IN THE MATTER Shaw's Property Holdings Ltd, 928 Kaipaki Road, RD3, Cambridge
3495, Land Use Consent for a Discretionary Activity for the
establishment and operation of a mineral extraction activity (sand
quarry) under the Waipa District Plan

**STATEMENT OF EVIDENCE OF MARK JOHN APELDOORN ON BEHALF OF THE
SUBMITTERS: AMANDA AND KEITH WALKER**

(TRAFFIC)

Proposed Sand Quarry – 928 Kaipaki Road, Leamington, Transportation Peer Review

Figure 4: Waipa District Council Water Supply Service (Source: Waipa District Council Utilities GIS Maps Service)

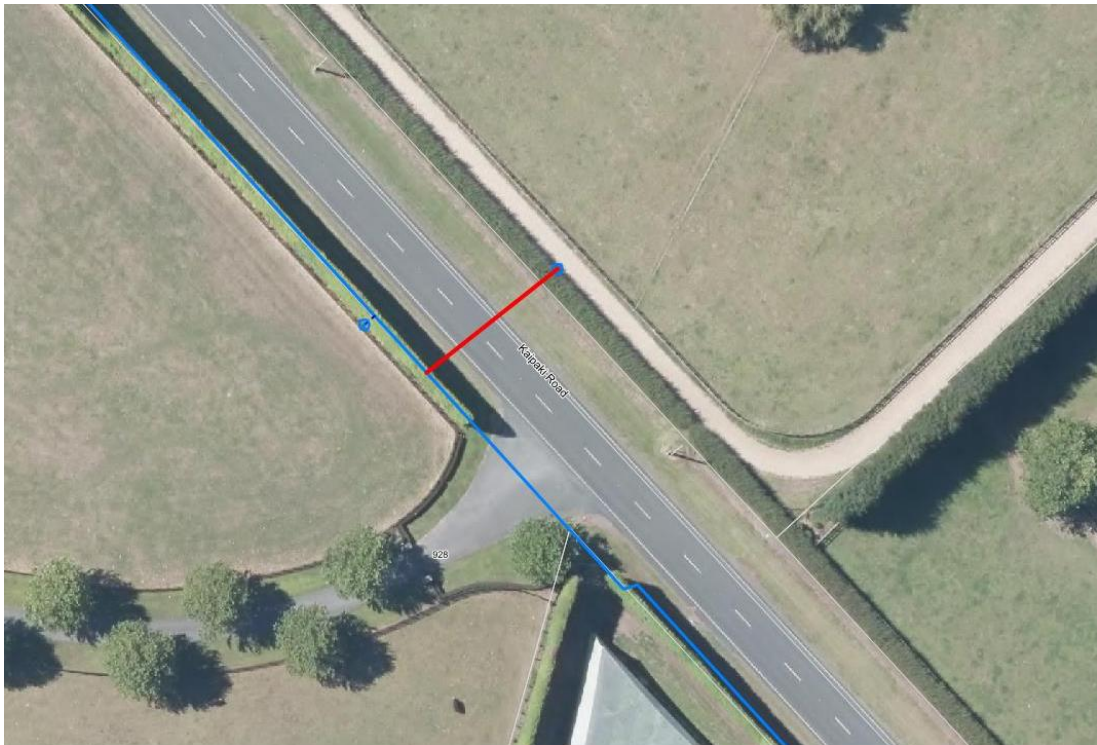
- (ii) A metered water supply connection is shown on the Council GIS map system servicing the Walker property (**Figure 4**) and will need to be crossed and secured;

- i) *Continued provision of at least an equivalent standard of accessibility, unless otherwise agreed with the land owner, for the existing gate to the property directly opposite the proposed quarry site entrance.*

Figure 1 – Site Location and Walker Property (Sourced from Mitchell Daysh AEE, annotation added)

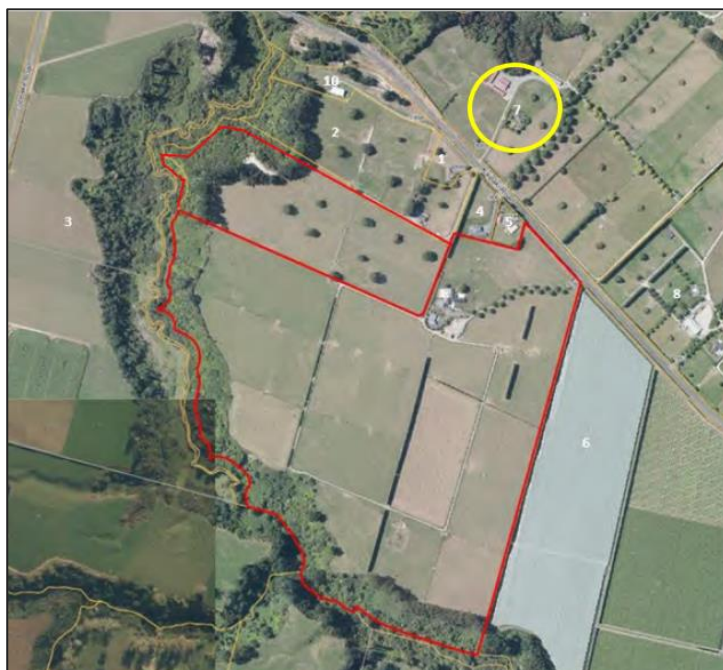
The Walker property is noted as Property 7 on Figure 1 below, which is reproduced from the Applicant's Assessment of Environmental Effects (AEE). The proposed quarry occupies approximately 49.83 hectares (ha) and is outlined in red on Figure 1.

Figure 2 – Diagram E Intersection Treatment

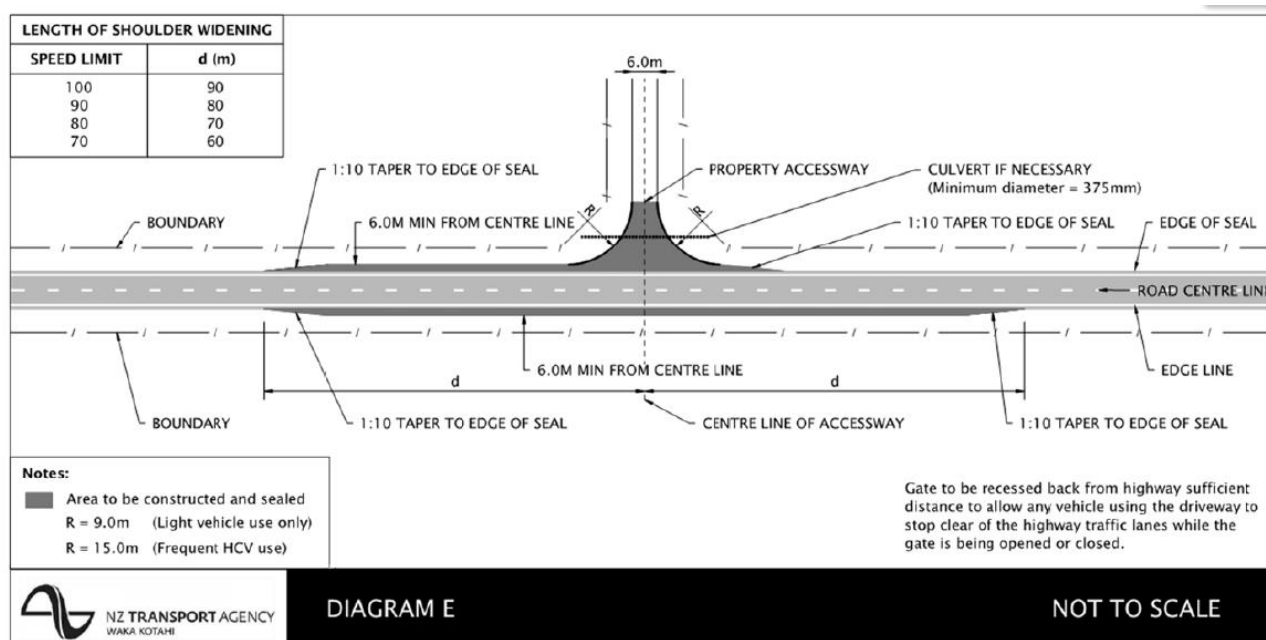
The proposed access treatment for the sand quarry is a 'Diagram E' layout, as shown indicatively below as Figure 2.

A simple calculation based on the proposed 106 HCV movements per day average cap indicates an expected 318 equivalent car movements per day. Based on the Planning Policy guidelines, the Diagram E treatment is most suited to accessway demands in the order of up to 100 ecms, a level about one third that anticipated by the proposal.

For accessways where higher utilisation is anticipated, the Planning Policy Manual recommends a more specific assessment. In the circumstances related to the demands expected of the access, it is recommended a more specific access arrangement involving:

- A painted right turn bay with storage and deceleration dimensions appropriate to the vehicle type, speed and access demands,
- Left turn deceleration facility similarly appropriate to the vehicle type and speed environment, and
- Acceleration shoulder areas are had regard for.

Figure 7– Austroads Warrant Assessment

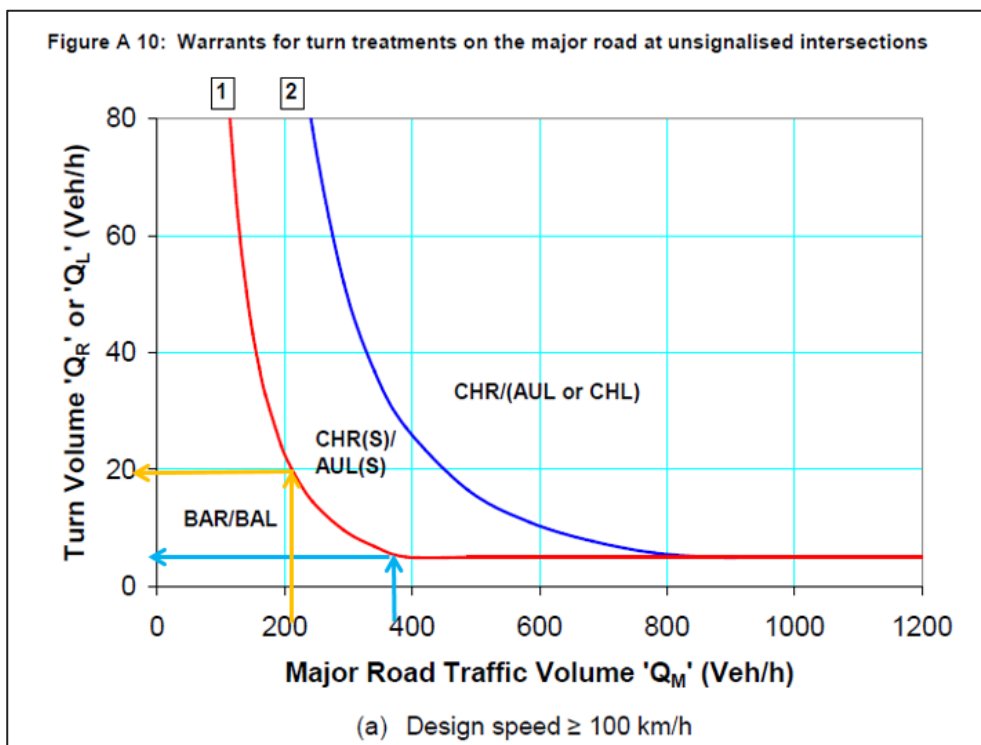
The left turn assessment (the orange arrows) considers only the north-westbound volume. These arrows show that something more than a basic left turn treatment (BAL) would be warranted if there were more than 20 vph turning left.

The ITA predicts up to 14 vph when the quarry is extracting 5,000m³ per week. Half of these movements would be inbound. Even if all the demand came from the south-east (Cambridge) side, an auxiliary left turn lane would only be justified if the peak hour generation was 40 vph, 2-3 times higher than the ITA predicts.

The right turn assessment (shown with the blue arrows) considers the two-way volume on Kaipaki Road. These arrows show that with any more than 5 vph turning right into the quarry, a standard higher than a BAR treatment, such as a right turn bay, would be warranted.

This threshold is different to what is cited in the AEE (8 vph). The basis of that calculation is not presented in detail however the difference is likely to have arise because of different assumptions regarding the existing and future volume on Kaipaki Road.

The ITA predicts up to 14 vph when the quarry is extracting 5,000m³ per week. Half of these movements would be inbound. Should the majority of that demand come from the north-west (Ohaupo) side for a given period, a right turn bay is likely to be warranted.

- The need for a right turn bay be reviewed on the basis of actual hourly count data by direction, and an appropriate allowance for future growth over the life of the quarry.
- The corresponding Diagram E shoulder widening arrangements for the left turn deceleration facility are assessed to be broadly appropriate, however further consideration may wish to be given to lengthening this shoulder area to accommodate the full deceleration requirement for heavy vehicles clear of the through traffic lane, avoiding delay and disruption to following traffic.

Figure 9— Expected Truck Speeds

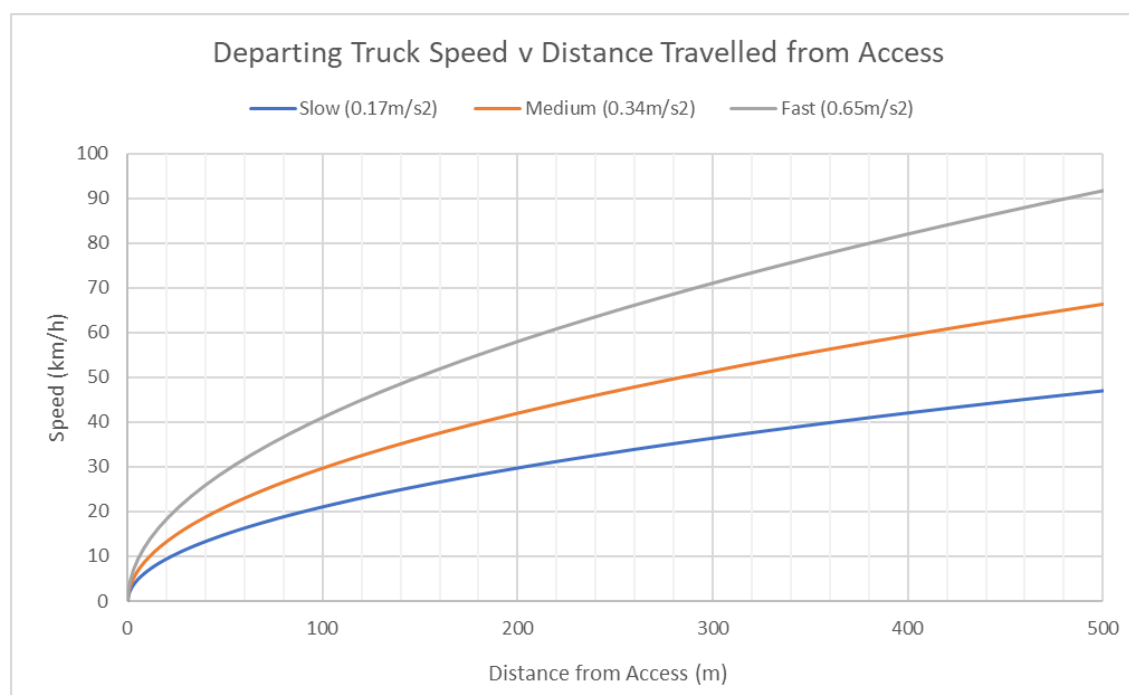
Figure 9 presents an estimated range of speeds for trucks on Kaipaki Road as they travel away from the proposed quarry access. The analysis applies to trucks travelling either direction.

After travelling approximately 100m from the site, trucks are expected to be travelling at speeds of 20-40km/h. By 200m, this increases to 30-60km/h and by 400m the range is 40-85km/h. For context, these 100m increments are shown on Figure 10 below, radiating outwards from the property access.

Figure 10– Indicative Distances from Property Access

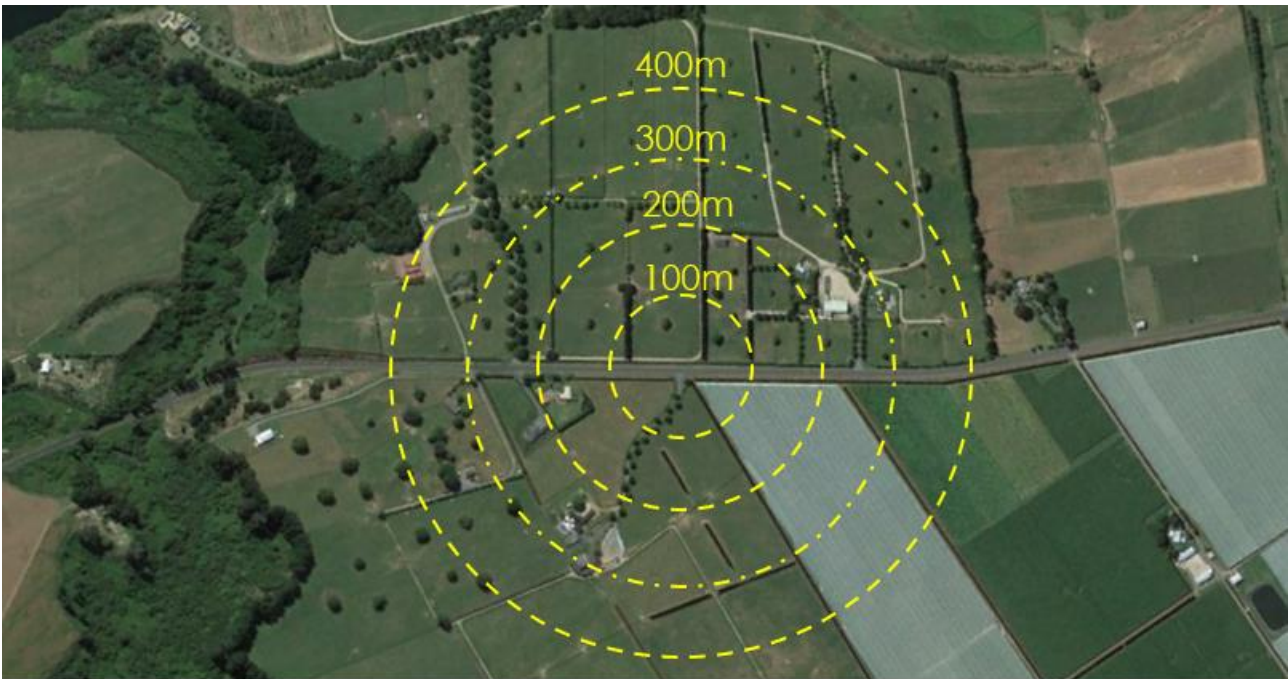
It is reasonable to expect that with trucks moving at noticeably less than the posted speed limited on Kaipaki Road, faster moving vehicles that enter the straight behind them may be tempted to overtake. The quarry access joins the straight approximately 350-400m from the vertical and horizontal curves at either end.
